# 05

## Comments and Responses – Railway Corridor

Figure: 5-3  
Sheet 1 of 14

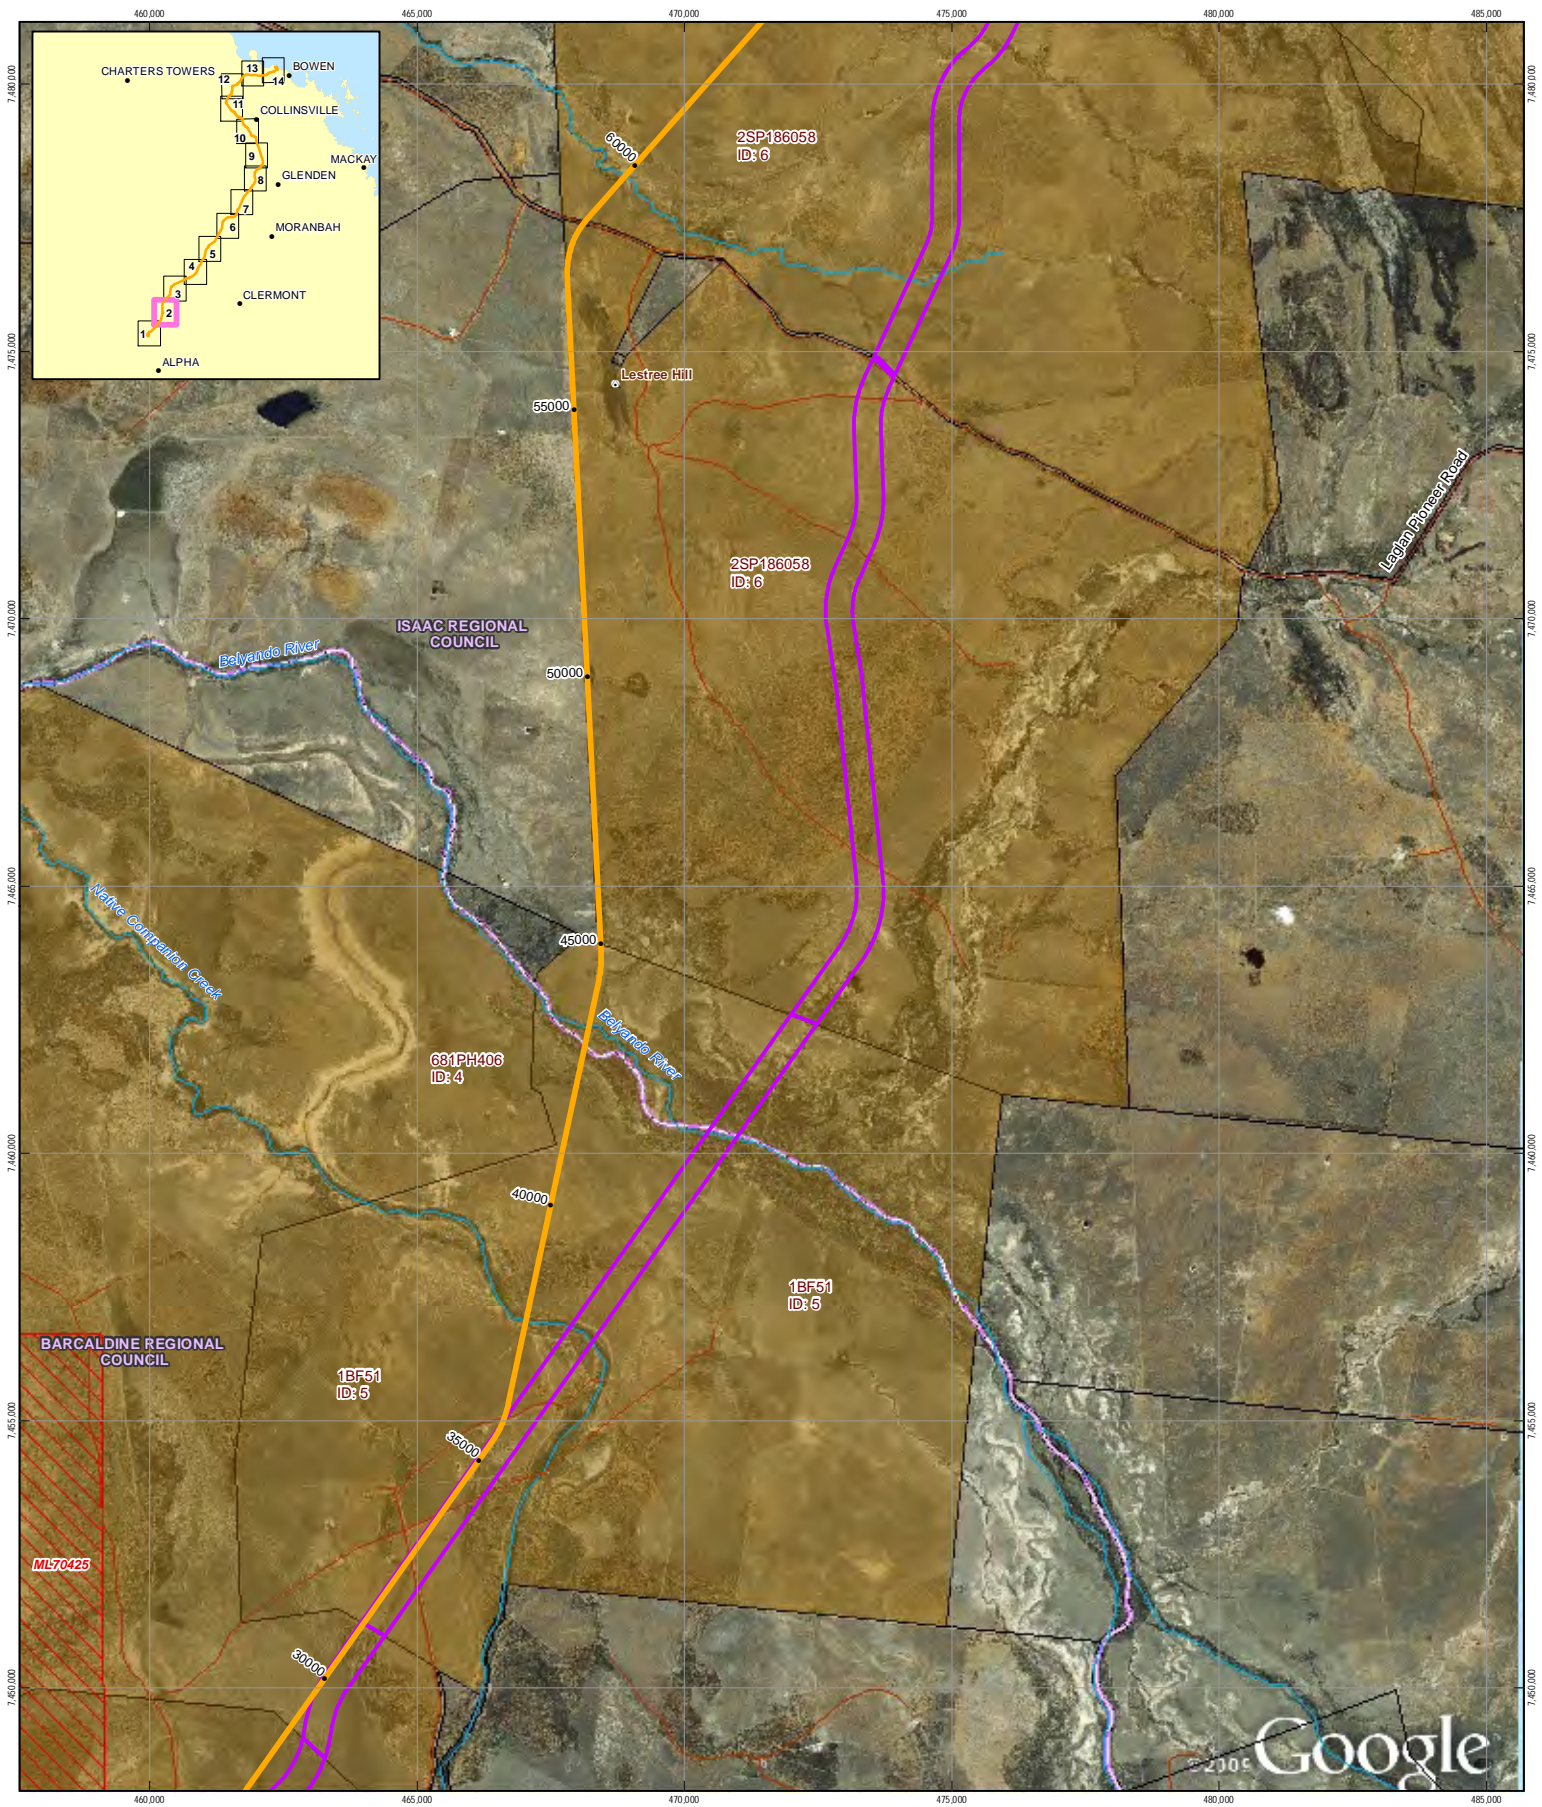
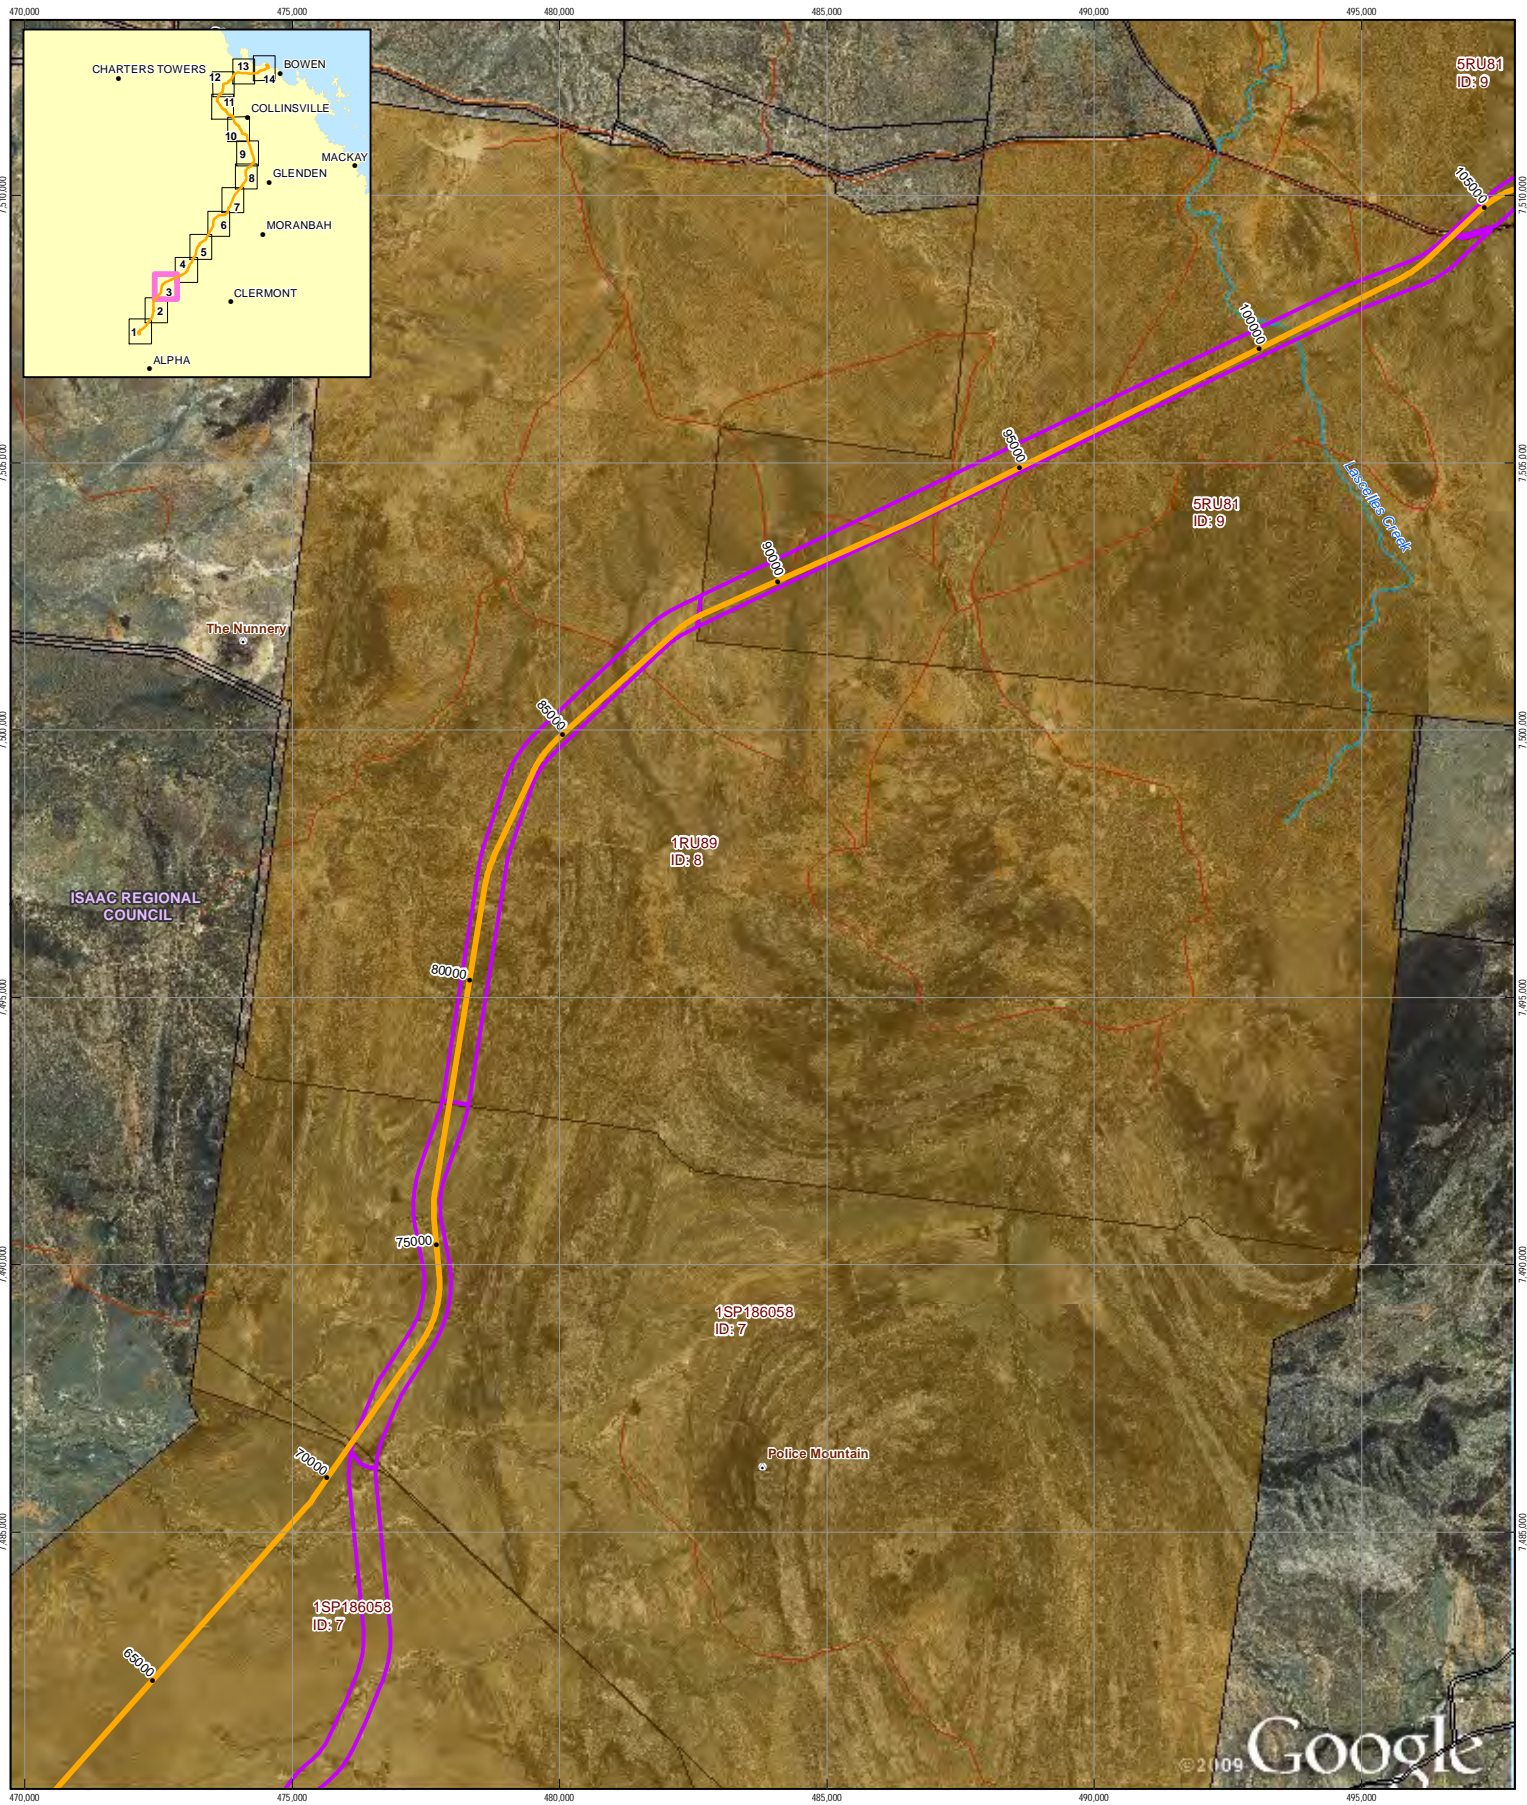
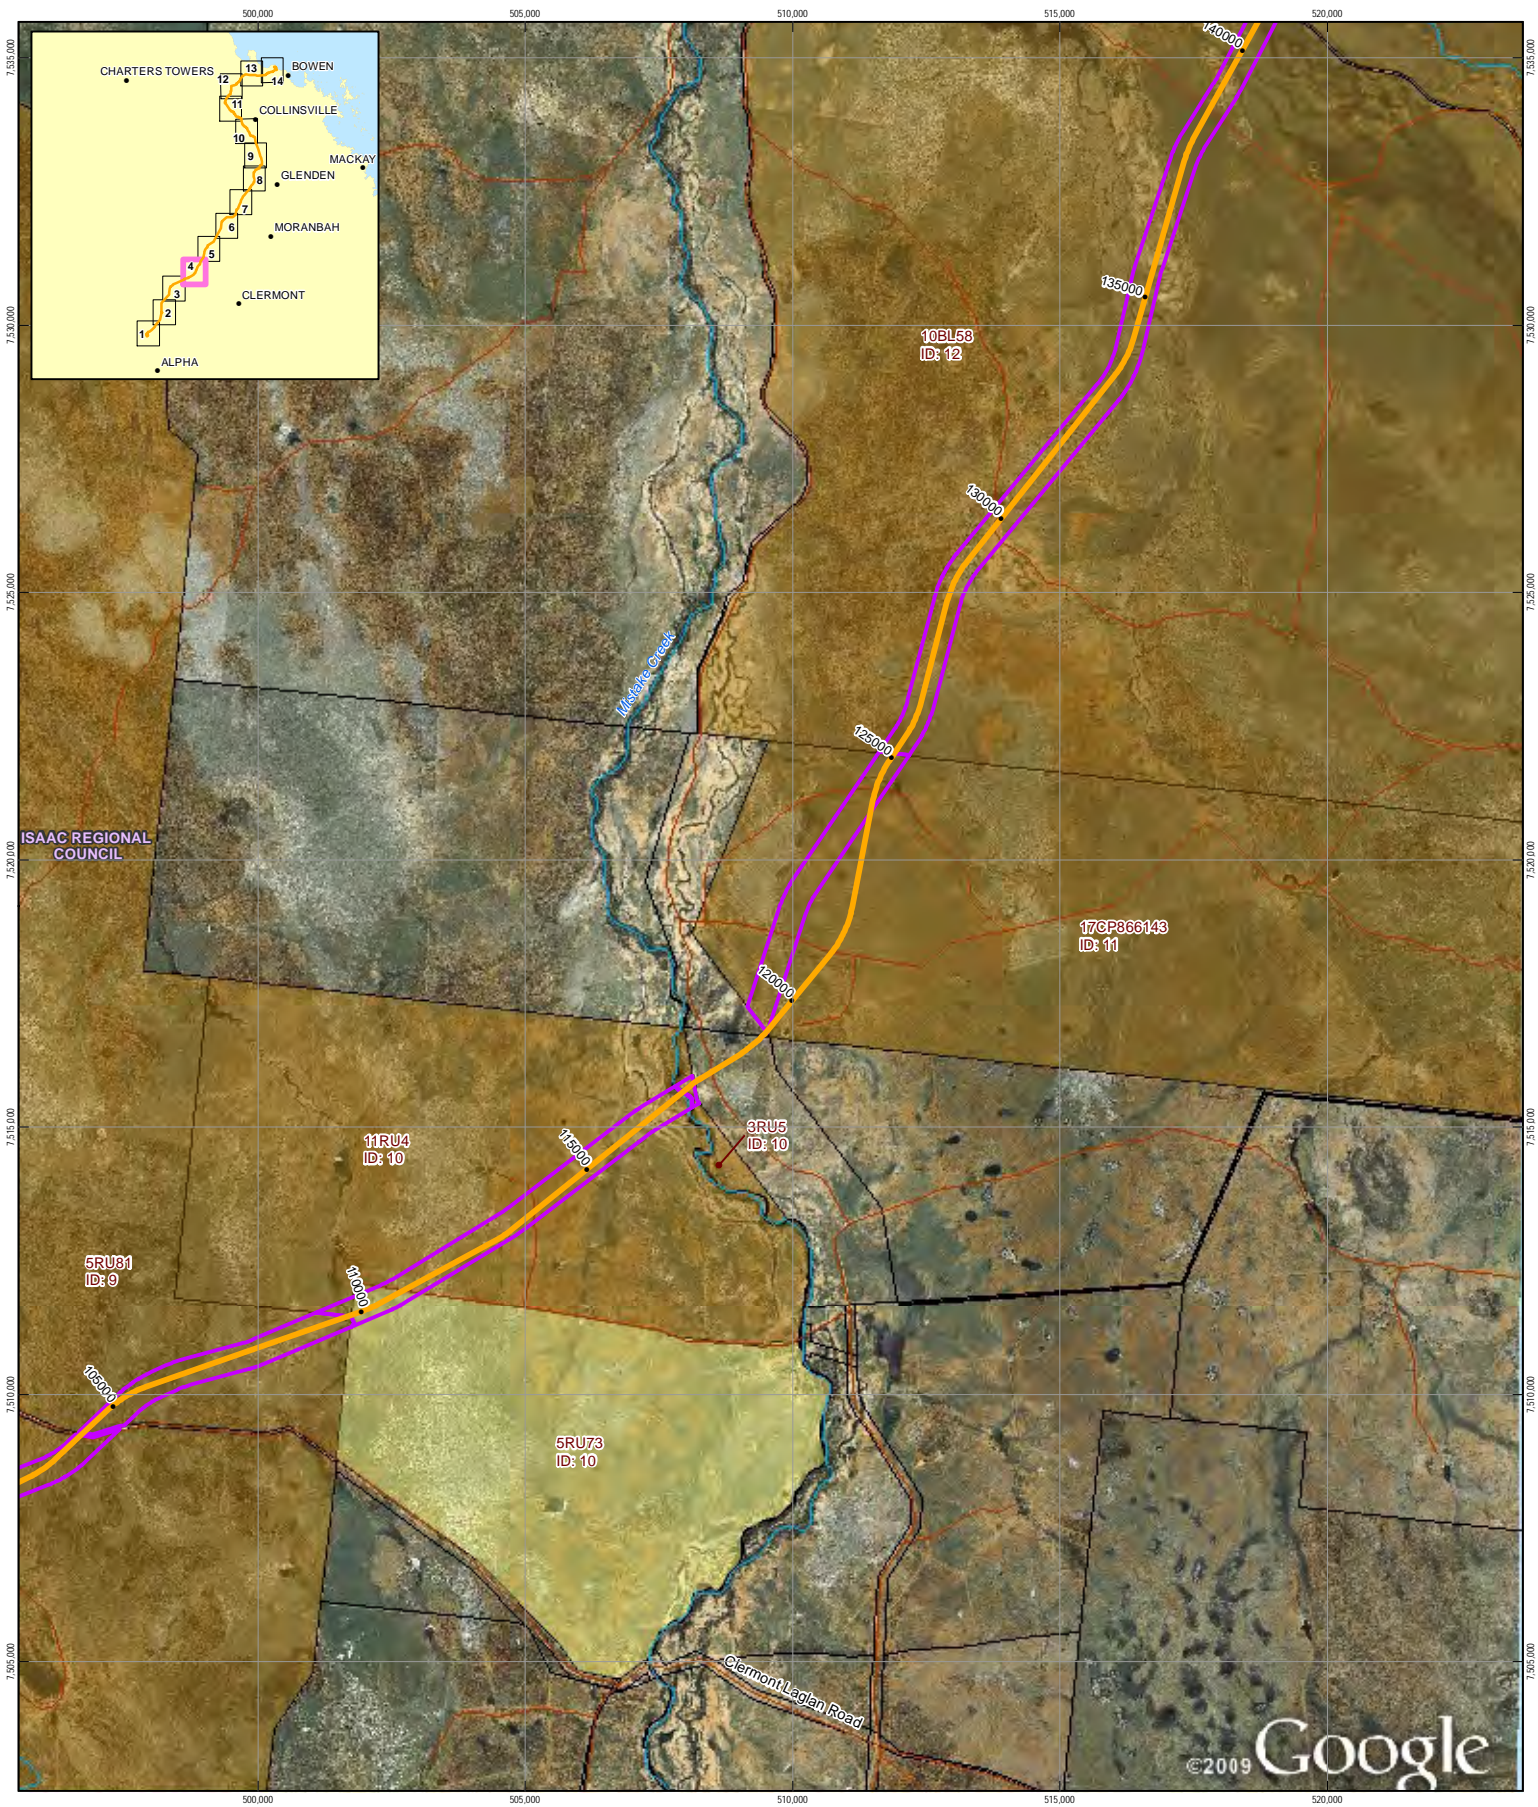
**Comment – RC405**

*The proponent has not delineated applications for MDL443 and MLs 10355, 10356, 10357, 70434, 70435 and 70436 on Sheets 8 and 9 of Figure 6. 2.*

Refer to amended Figure 5-3 below.
